NOTICE OF A TYPE II DECISION ON A PROPOSAL IN YOUR NEIGHBORHOOD

CASE FILE NUMBER: LU 18-176338 DZ : 3-STORY, 16 UNIT BUILDING PROVIDING RESIDENTIAL DEVELOPMENT

Site Address: **5308 SE 18th Avenue**

2 NORTH ELEVATION
1/4" = 1'-0" @ 24" x 36"
1/8" = 1'-0" @ 12" x 18"

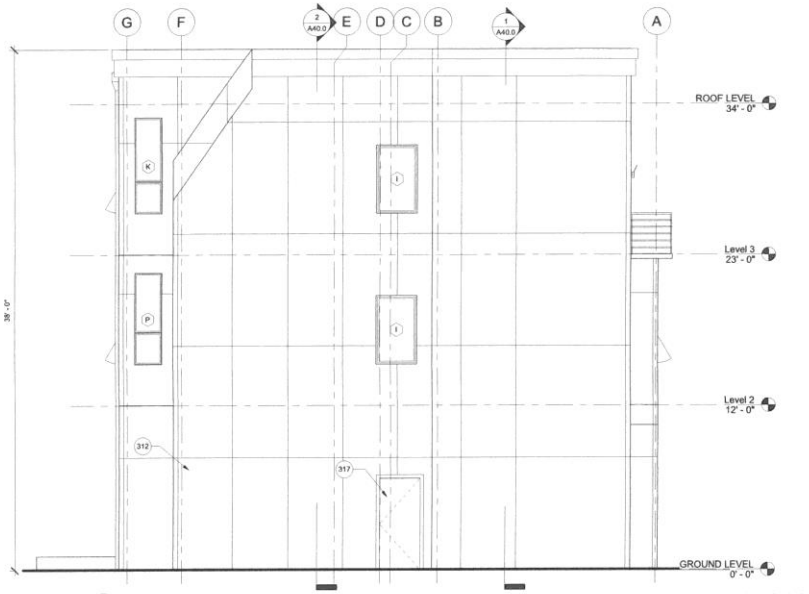
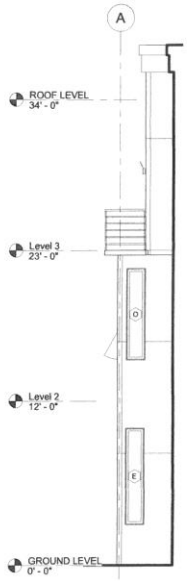
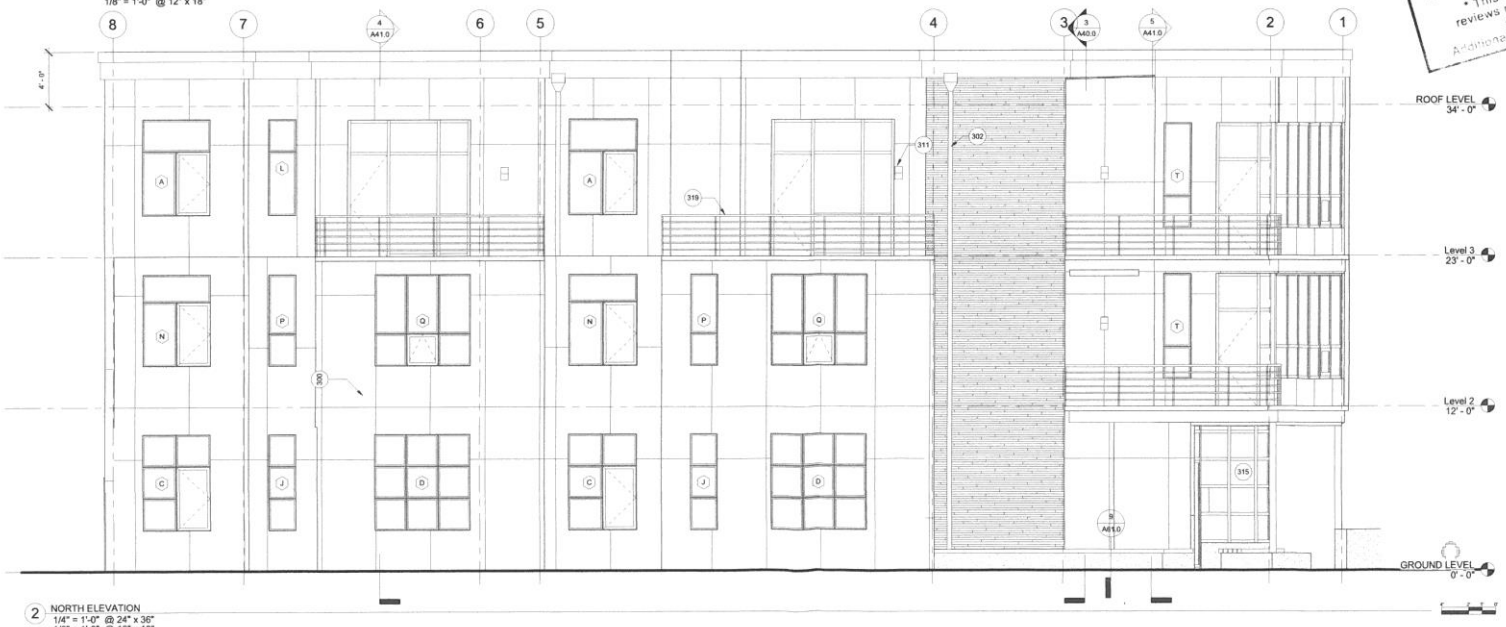
- Regarding the north, east and south elevations, exterior walls less than 30 feet to property line must be 1-hour fire-rated construction. Exterior walls located less than or equal to 10 feet to a property line must be one-hour fire-rated for exposure to fire from both sides. Exterior walls located more than 10 feet to a property line must be one-hour fire-rated for exposure to fire from the inside only. OSSC 602.1, 705.5

- Regarding the north, east and south elevations, the maximum area of unprotected and protected openings permitted in an exterior wall in any story of a building shall not exceed the percentages specified in OSSC Table 705.8. OSSC 705.8.1

1. Proposed Cembrit fiber-cement panel with integral color will be oriented horizontally as shown in Exhibit C-12, not as shown in elevations – Exhibits C-6 and C-7.
2. Proposed windows and storefront systems must have an inset or "punch" of not less than 4" as measured from the glass to exterior trim.
3. Proposed metal screen must be 20 gauge or lower.

C. Proposed Cembrit fiber-cement panel with integral color shall be installed in horizontal panels, per renderings, not as shown in rendering in Exhibit C-12, not as shown in elevations – Exhibits C-6 and C-7.
